EXPERT JOINT WITNESS STATEMENT (JWS)

Case: Application for resource consent to discharge contaminants to land, air and water associated with the proposed long-term upgrade and operation of the Featherston Wastewater Treatment Plant - *Before Commissioners for Wellington Regional Council GWRC WAR 170229 At Featherston*

Topic: Groundwater and related Wastewater and Land Treatment Expert Caucusing

Date: 18 December 2018 = date of caucusing. Amendments have been included and agreed up to the date of signing (see page 2).

Figure 7 Depth to Water table showing Areas with <0.6 m Vadose Zone Thickness

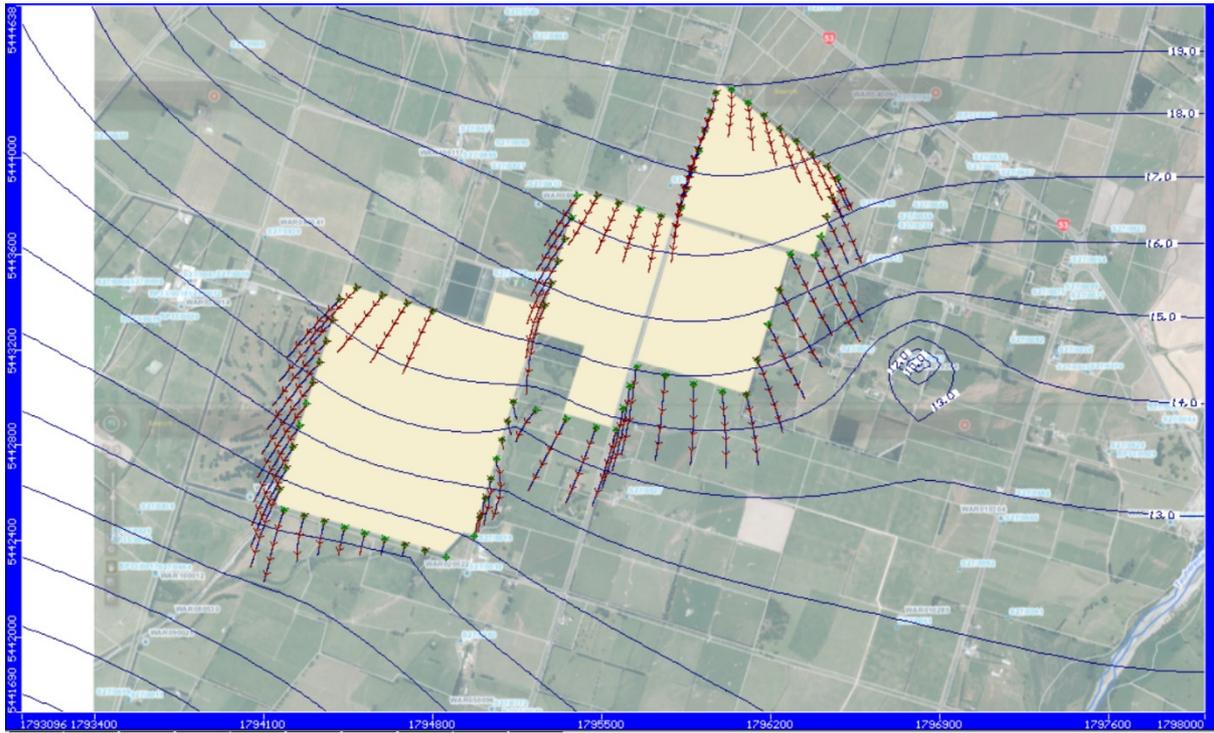
2	<p>What is an acceptable (in terms of risk and nature of effect) magnitude, (i.e. water level relative to ground level), duration, and frequency of groundwater mounding both on and off the proposed land application site? <i>[Expert brief item b]</i></p>	<p>- Groundwater mounding that results in Vadose zone thickness reduction to less than 0.6m is considered <u>unacceptable</u> under any conditions [Onsite].</p>		<p>- Acceptable offsite groundwater mounding effects have yet to be considering following further modelling and uncertainty analysis by the Applicant.</p>
3	<p>Over what land area might this mounding occur and how does it alter over different inflow, irrigation and climatic scenarios? <i>[Expert brief item c]</i></p>		<p>- This has yet to be received from the Applicant so cannot yet be agreed upon. - Awaiting further information/assessment from the Applicant, including modelling report, assessment of wet year scenario, and assessment of lower I&I reduction scenario [see Item 6].</p>

4	<p>What is the likelihood of unacceptable mounding at Stage 1B, 2A and 2B. <i>[Expert brief item d]</i></p>		<p>- This has yet to be reviewed and agreed upon. - Awaiting further information/assessment, including modelling report and assessment of wet year scenario, assessment of lower I&I reduction scenario, and consideration of Stage 1B (prior to I&I reduction) mounding.</p>

[see Item 6]	
5	Is the level of certainty with respect to potentially unacceptable mounding at each stage adequate and acceptable to allow an assessment of effects? <i>[Expert brief item e)]</i>		Insufficient data presented to date to enable PDP to assess effects due to mounding.. [See Item 4 statement]	
6	What additional information is required to address residual uncertainty to an acceptable level, and is it that information obtainable? <i>[Expert brief item f)]</i>	<ul style="list-style-type: none"> - Field investigation summary document (from Nov-Dec 2018 works) [LEI] is required to support the hydrogeological assumptions adopted for the modelling work particularly the thickness of gravel geology, presence/absence of finer grained soil layers, and overall groundwater level and flow conditions. - Groundwater Modelling Technical Report "Appendix B" to GWS 14 December 2018 document "Further Evaluation of Groundwater Effects Associated with the Land Application of Wastewater at Featherston" [GWS] is 	Sensitivity analysis is required based on a less effective I&I reduction scenario occurring (below the currently assessed 35% flow reduction due to I&I remediation works). This has yet to be agreed on.
